13 September 2010

Modification of Major Project Approval No. 06-0243 Fraser Drive, Tweed Heads South

Thank you for your emails of 1 July 2010. Our responses to the various issues raised are as follows:

We attach three (3) copies of the amended Proposed Subdivision Plan (B & P Surveys, Drawing No. 17900B-D, 19 May 2010) showing the proposed pathway between Lots 80 and 81 and the proposed overland flow path/drainage reserve between Lots 151 and 152.

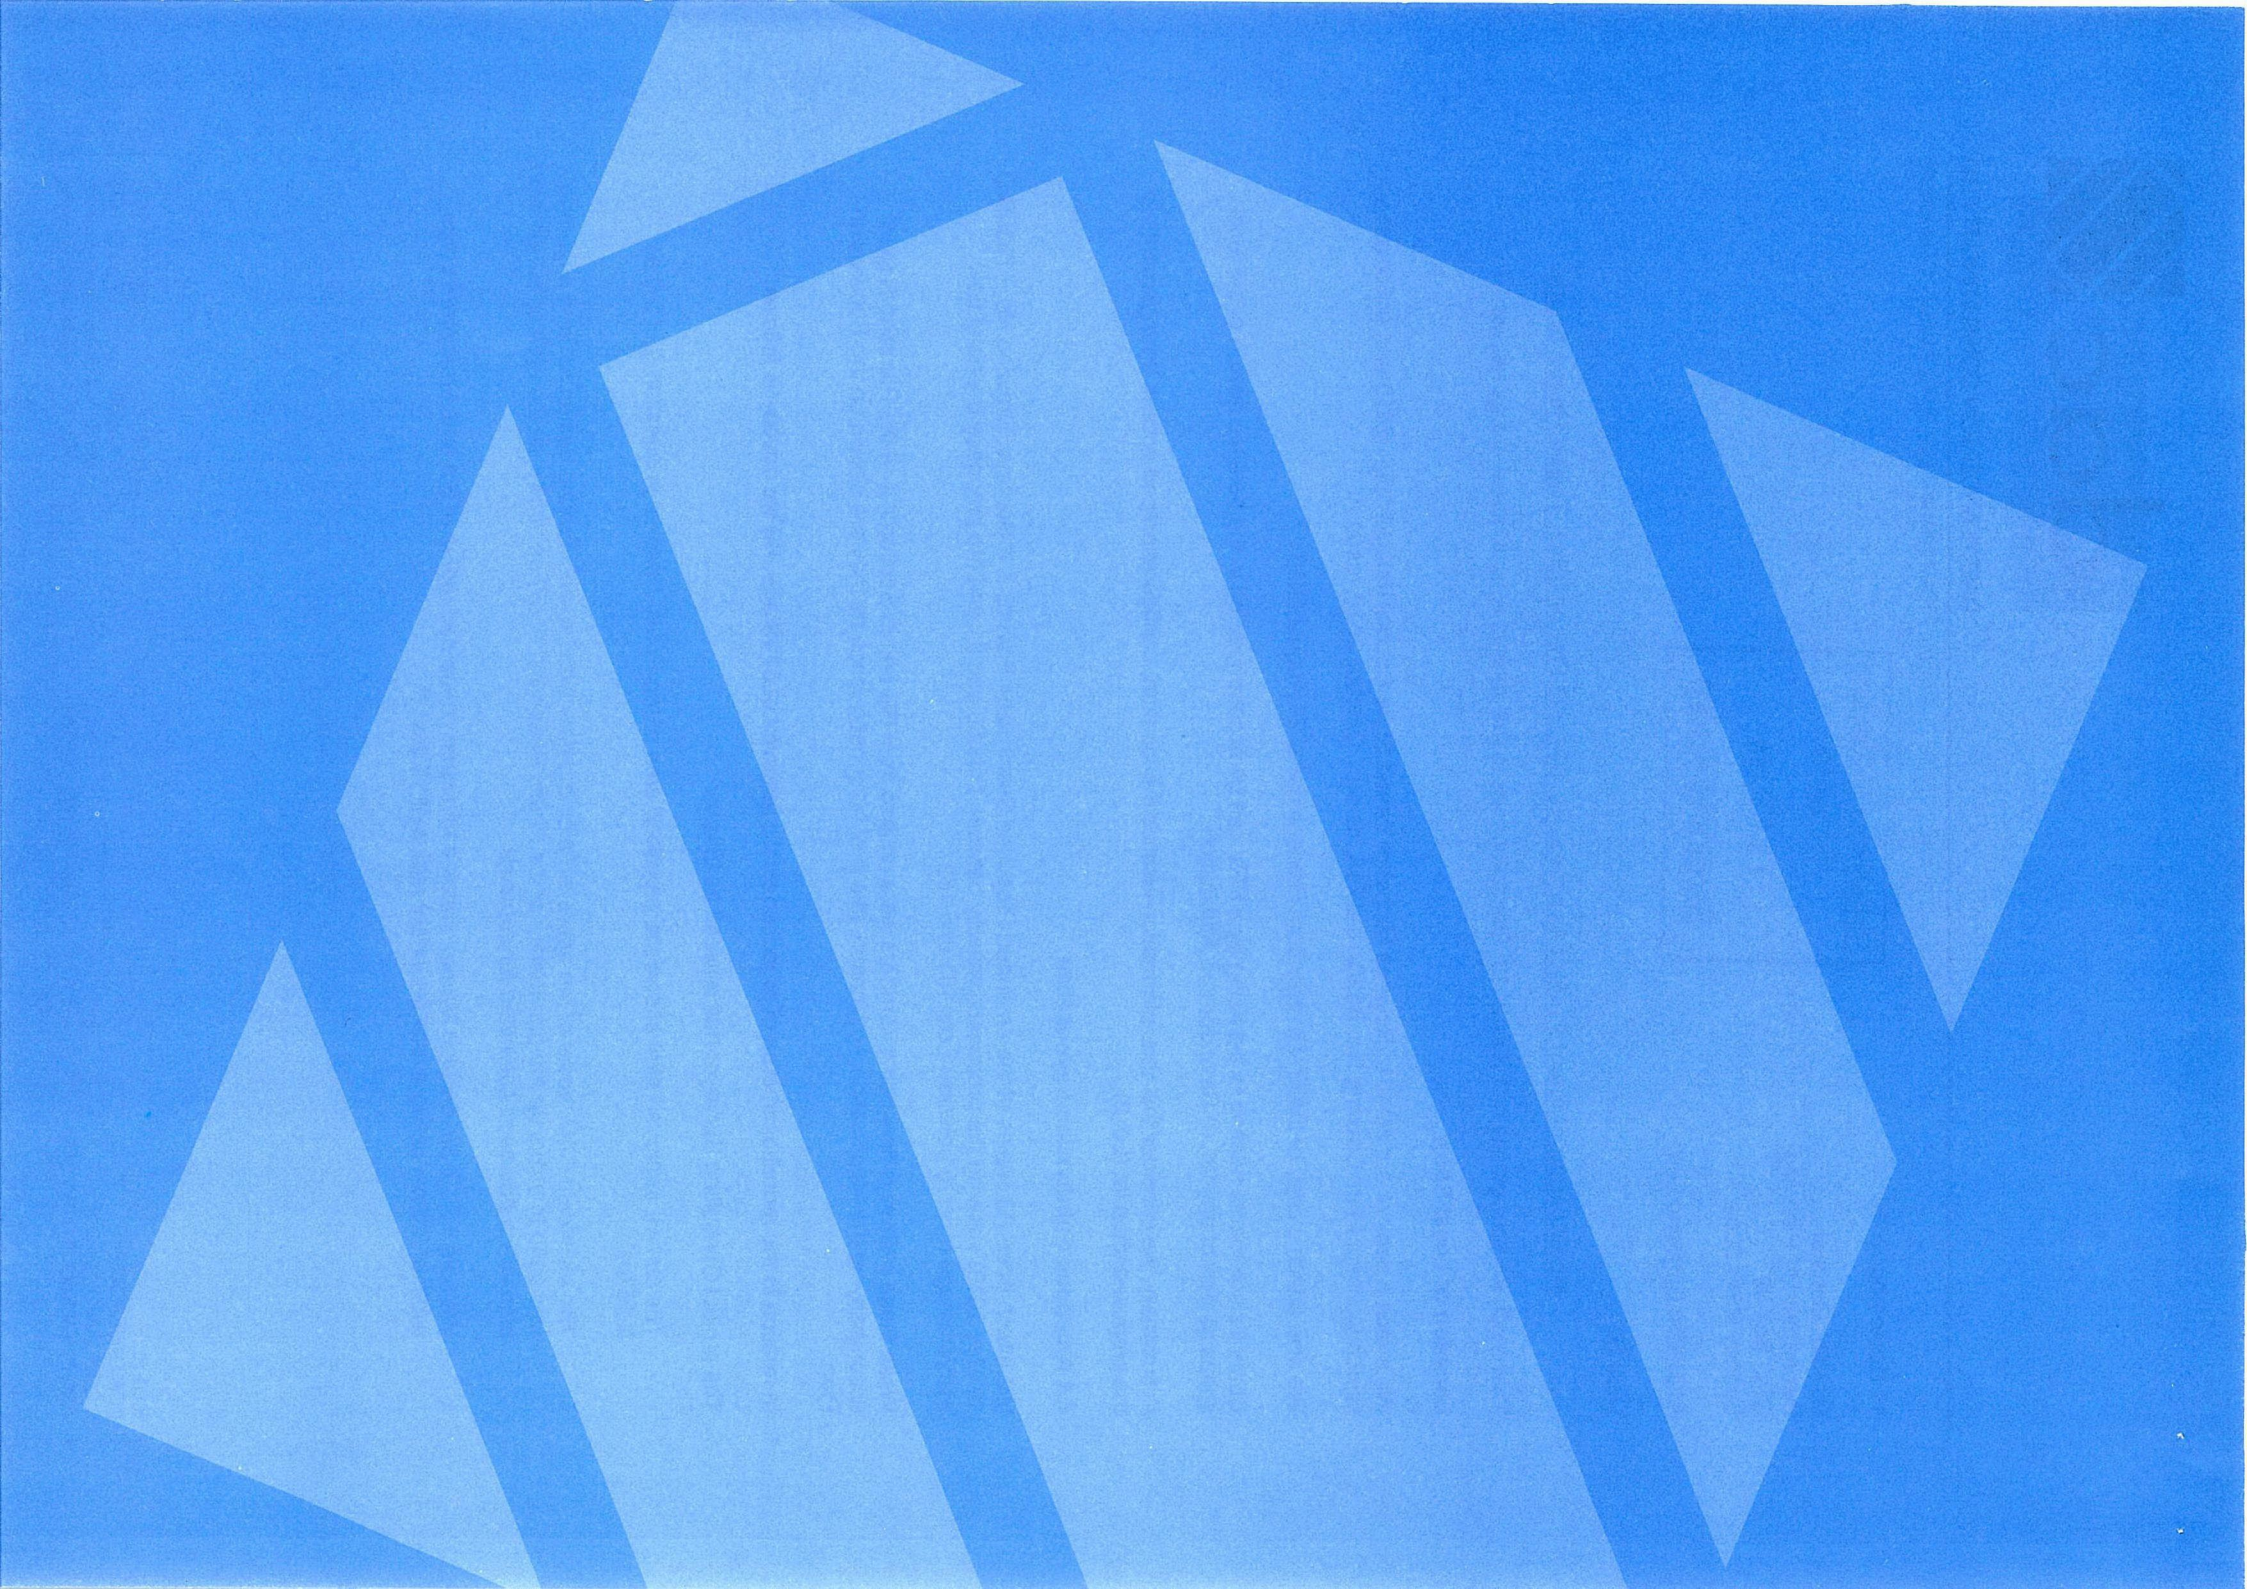
In relation to the reduction in area of proposed public reserve Lot 57 (Stage 3A) we advise as follows:

- *The current approved plan shows the proposed area of the Public Reserve in question (Lot 57) as 2,267m².*
- *The electronic CAD model of the approved plan together with the engineering design for kerb alignments was used to calculate the boundaries of the Public Reserve (Lot 57) as shown on the revised subdivision plan which has been submitted for approval.*
- *We note TSC's Subdivision Manual states a minimum cul-de-sac radius of 9m and a minimum verge width of 3.5m – giving a total boundary radius of 12.5m.*

- *On close inspection of this electronic CAD model it became apparent that the approved plan had a total boundary radius of 11.75m which does not comply with TSC's minimum standards. A similar design error was detected on the northeast of lot 57.*
- *Hence the new boundary alignment on the revised proposed subdivision plan has adopted the correct boundary alignment widths as required by the Tweed Shire Council Subdivision Manual thus resulting in a reduced area of approximately 50 m²."*

In conclusion, we therefore submit that the minor reduction in the area of Lot 57 is unavoidable and of no planning consequence as there is more than adequate usable casual open space proposed within the development site.

The amended Subdivision Layout Plan No. 17900B-D attached shows the corridor between Lots 151 and 152 as an overland flow/drainage reserve as that is its key function rather than a pathway.

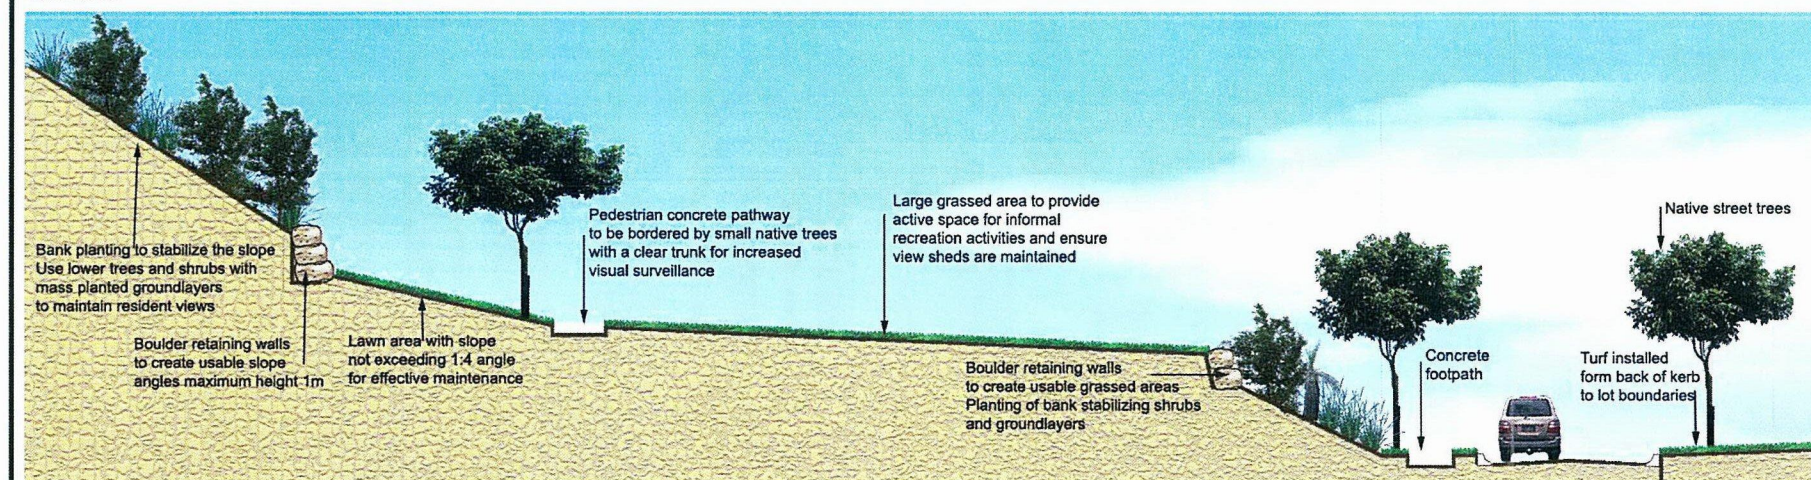
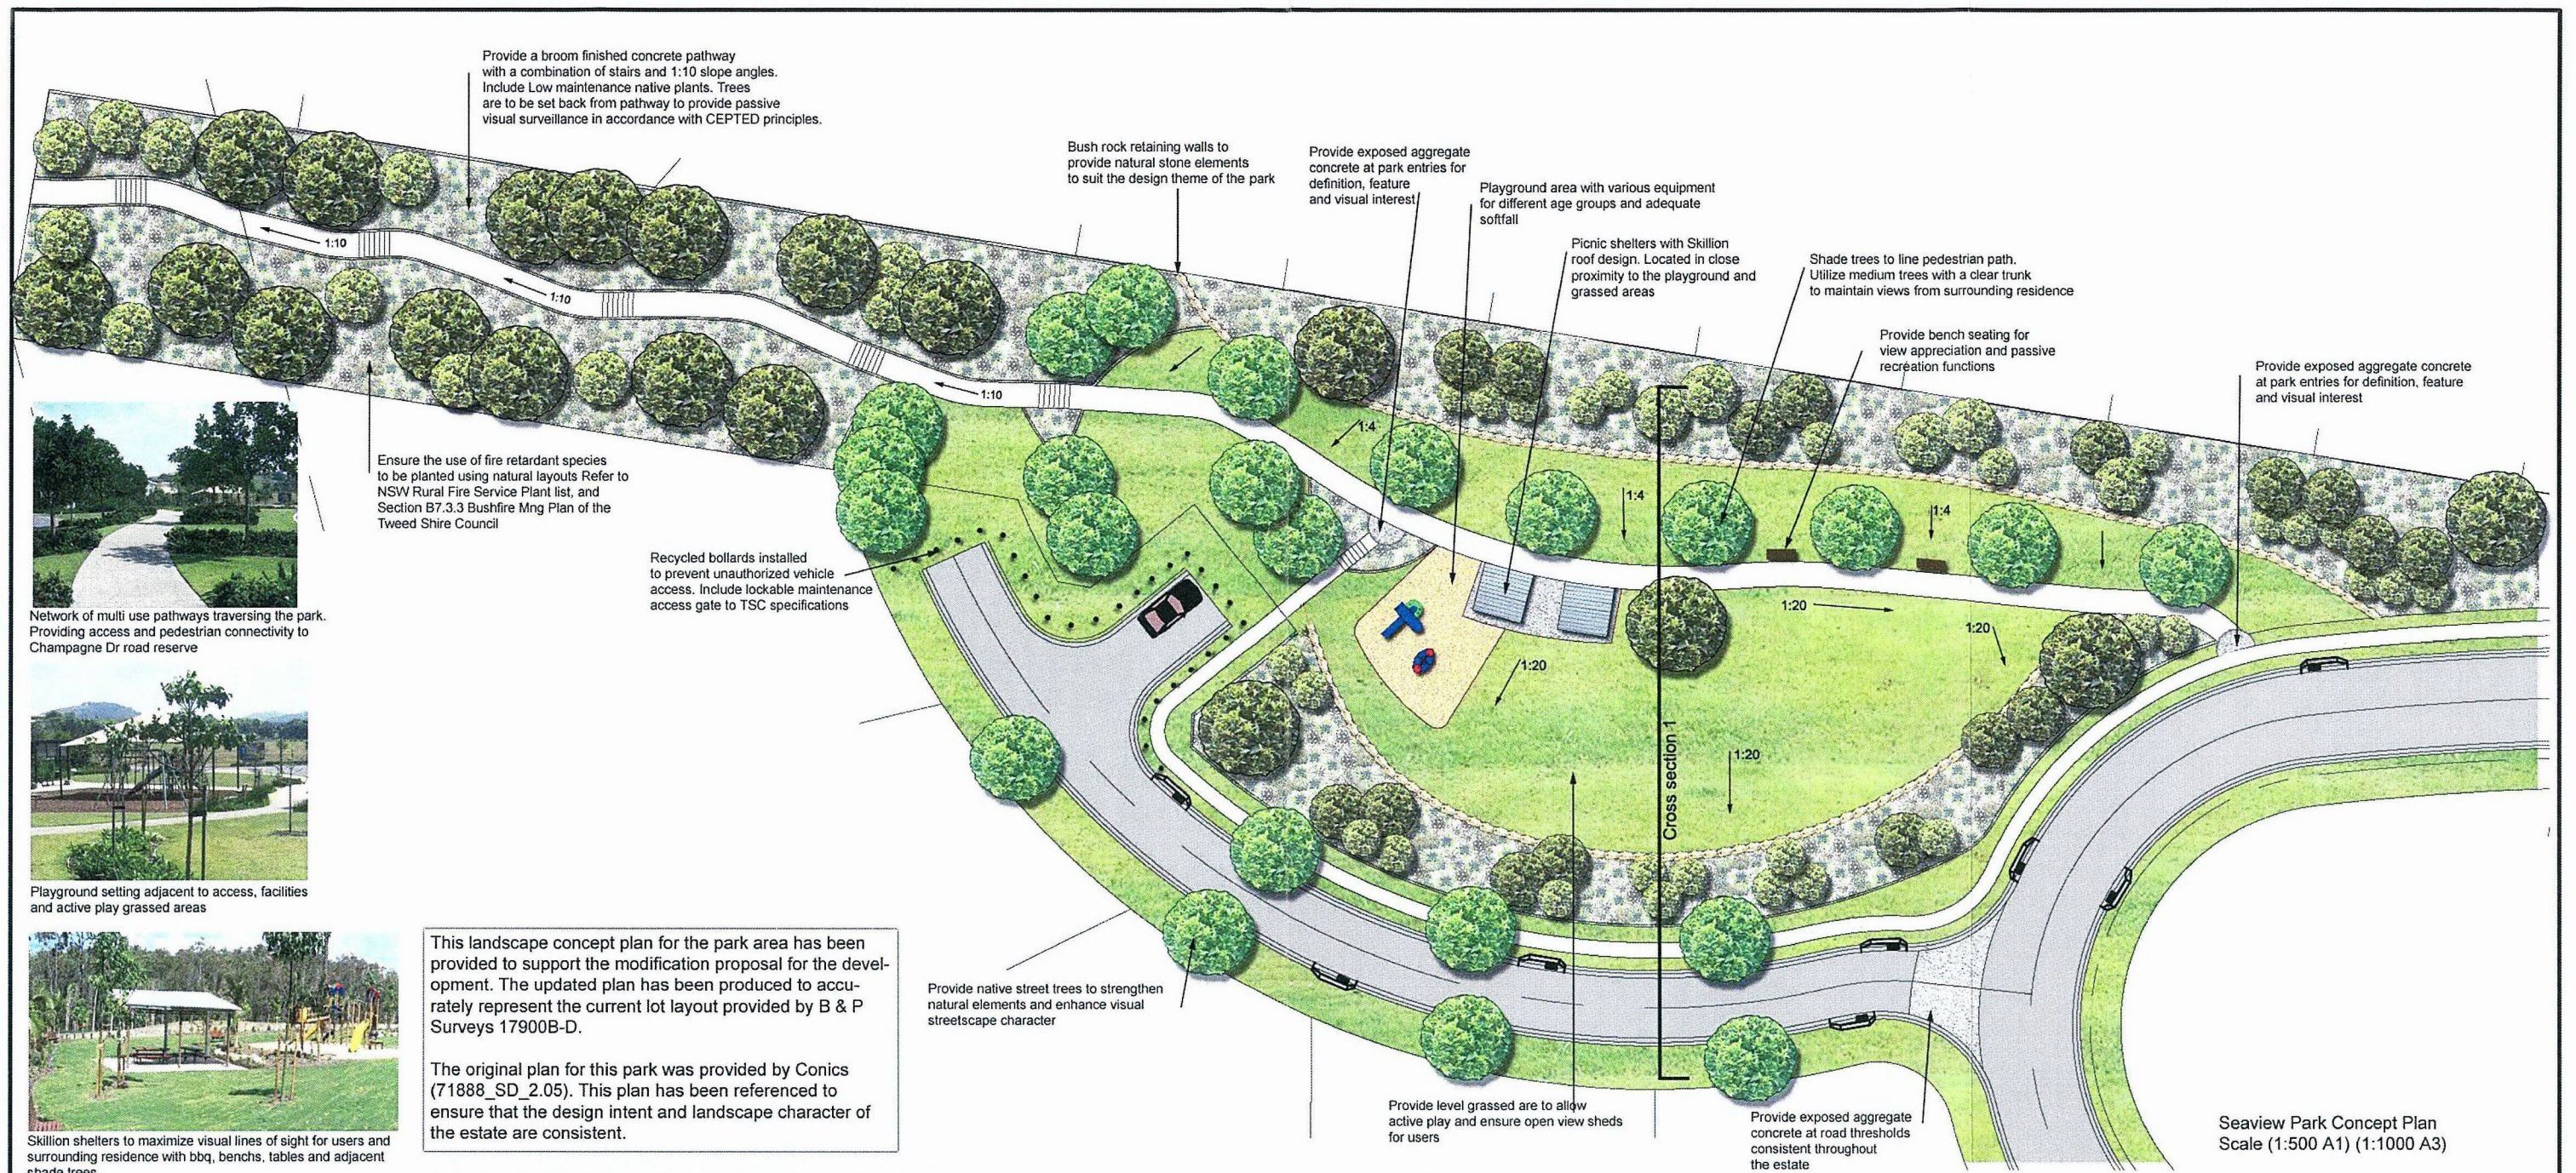
The submitted noise assessment recommended that the future construction of dwellings on Lots 22-30, 71 and 125-134 to have regard to appropriate acoustic treatment and relevant building standards. Clarification is required in relation to predicted noise impacts on Lots 90, 104-105 and 113 - which are also adjacent Fraser Drive - to determine whether reference to these latter lots should be included within the Statement of Commitments.

The Lots 90, 104 – 105 and 113 will be exposed to road traffic noise levels below the threshold that triggers building shell construction above what is deemed standard construction (refer to the attached Traffic Noise Reduction calculation). Based upon AS 3671 – 1989 “Acoustics – Road traffic noise intrusion – Building Siting and Construction”, a Traffic Noise Reduction at or below 25 is deemed standard construction, and is discussed in more detail in Section 6.1.2 of our report. The noise level thresholds that trigger non standard construction are as follows:

- Daytime noise level of 71 dB(A) $L_{eq}(1hr)$ assessed in living spaces;
- Night period noise level of 66 dB(A) $L_{eq}(1hr)$ assessed in bedrooms.

It is noted that the worst impacted dwellings (being Lots 22 – 30, 71 and 125 – 134), will be exposed to noise levels of 71 – 72 dB(A) $L_{eq}(1hr)$ which are one decibel above the threshold level for standard construction.
